STATE OF MAINE  
DEPARTMENT OF TRANSPORTATION  
16 STATE HOUSE STATION  
AUGUSTA, MAINE 04333-0016

October 17, 2025  
Subject: Dover Bridge  
Bridge Replacement State  
WIN 023120.00  
Location: Dover-Foxcroft  
Amendment No. 2

Please make the following changes to the Bid Documents:

ROCK SOCKET DETAILS

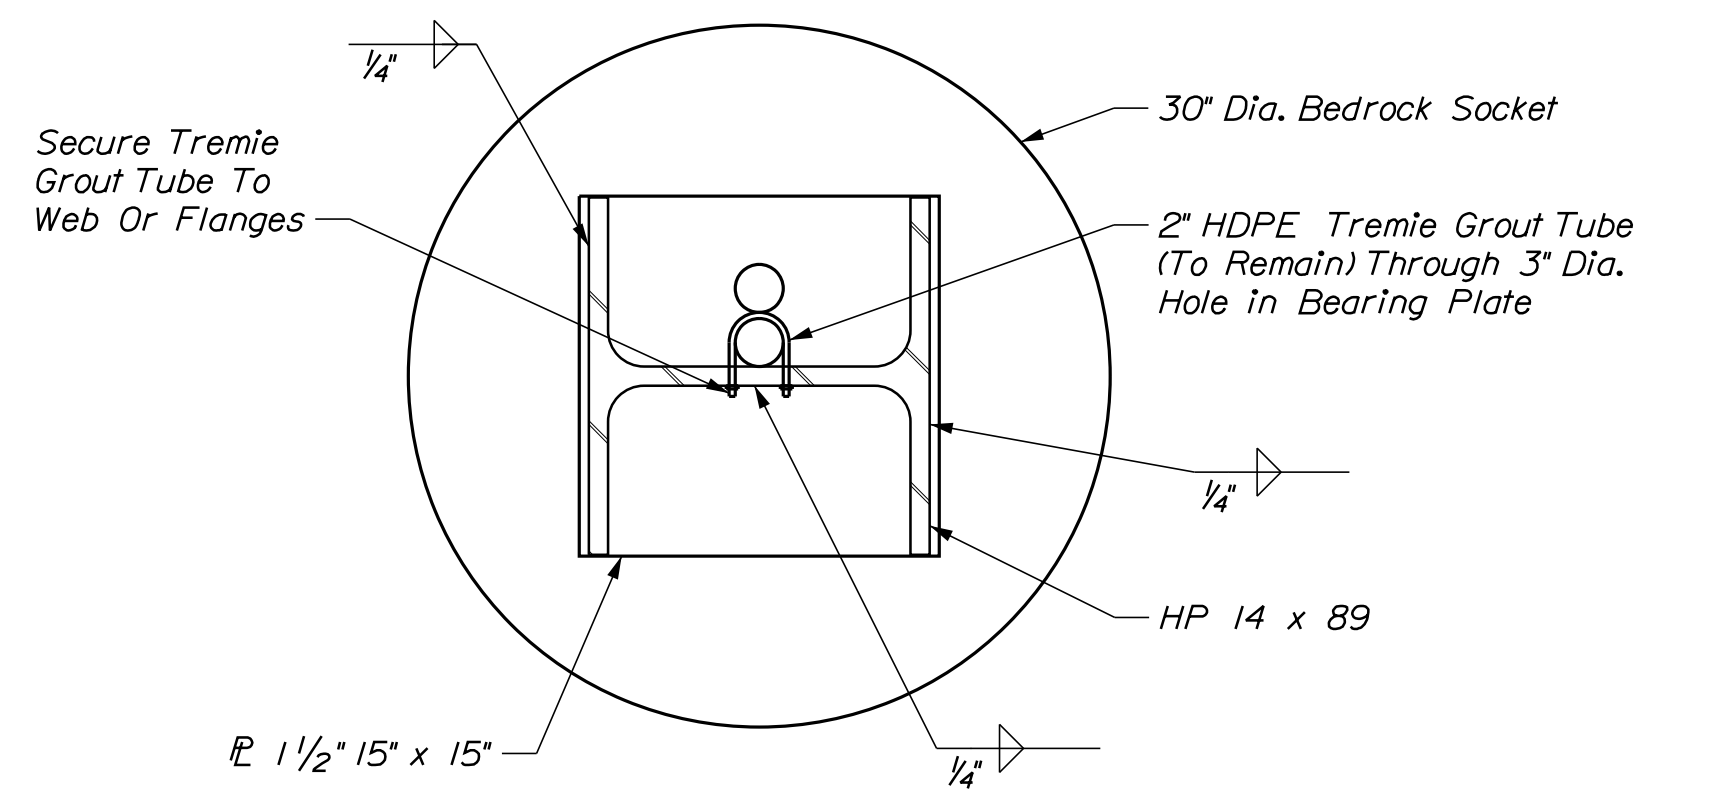
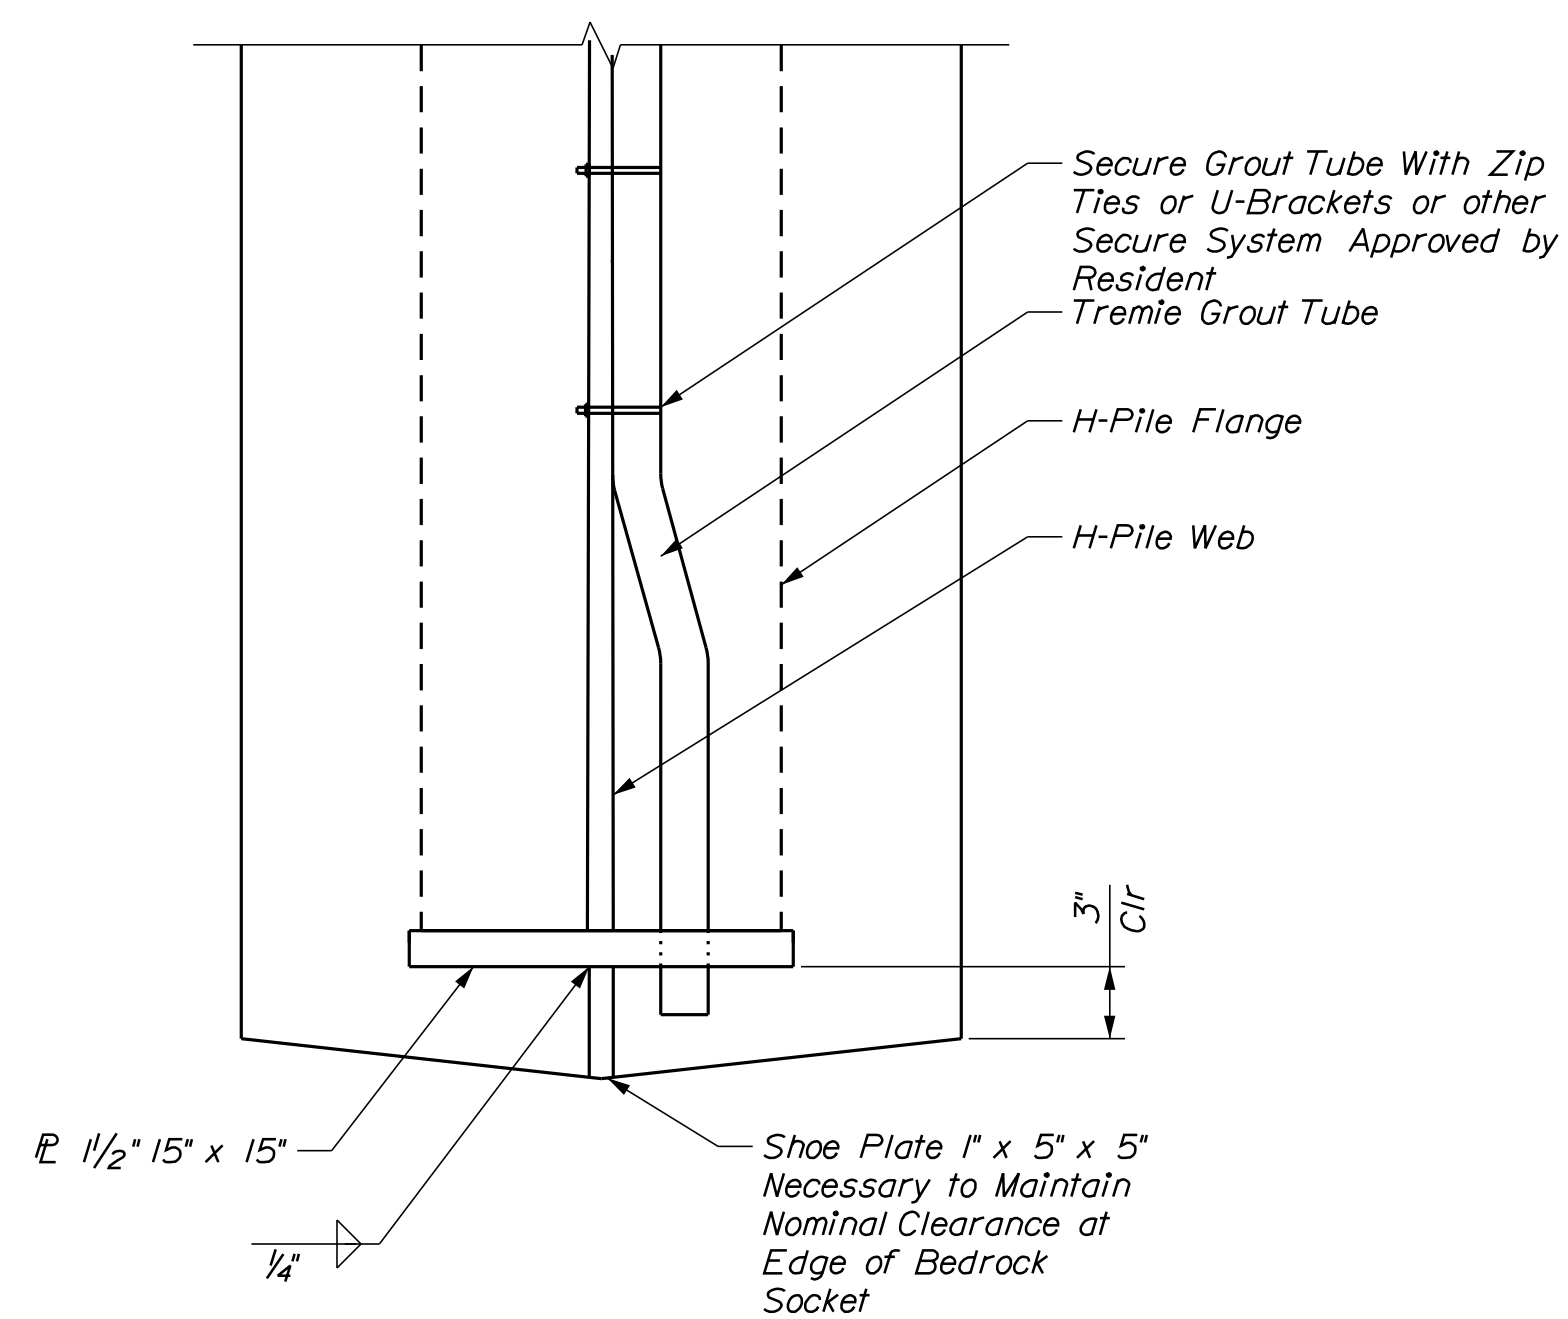
**REMOVE SHEET NUMBER 39 OF 64, ABUTMENT NO. 2 ROCK SOCKET DETAILS**, dated 8/27/2025, and **REPLACE** with the attached, revised **SHEET NUMBER 39 OF 64, ABUTMENT NO. 2 ROCK SOCKET DETAILS**, dated 9/24/2025.
